- **TIMING BELT NOISE—1.6L AND 1.6L TURBO—VEHICLES BUILT FROM JOB #1 TO 10/1/90**
- **NOISE—“SWISH” FROM TIMING BELT—1.6L AND 1.6L TURBO—VEHICLES BUILT FROM JOB #1 TO 10/1/90**

**Article No.  
94-17-5**

**MERCURY: 1991 CAPRI**

Figure 1 - Article 94-17-5

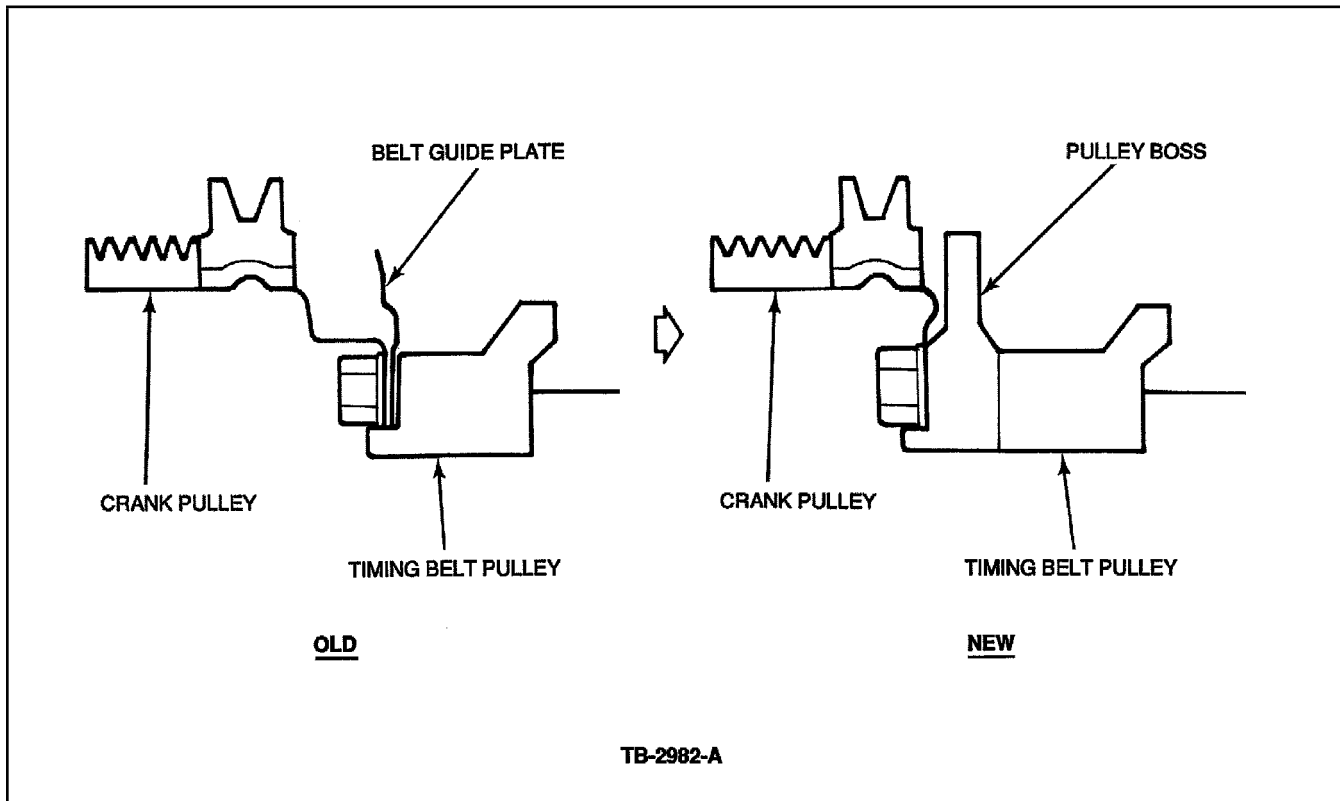
The timing belt may make a noise because the belt guide plate does not maintain proper belt alignment.

Replace the timing belt guide plate with a timing belt pulley boss. This will require replacement of the crankshaft and associated hardware, Figure 1. Refer to the Parts Block of this article for correct parts usage and to the 1991 Capri Service Manual, Section 21, for service details.

- The crankshaft timing pulley bolt torque specification has been revised to 157-167 N•m (115-123 lbs-ft).
- Adjust all drive belts to specification. Refer to the 1991 Capri Service Manual, Section 27-02, for specifications.
- Use Crankshaft Pulley Holder (T92C-6316-AH) to remove and install the timing belt pulley lock bolt.
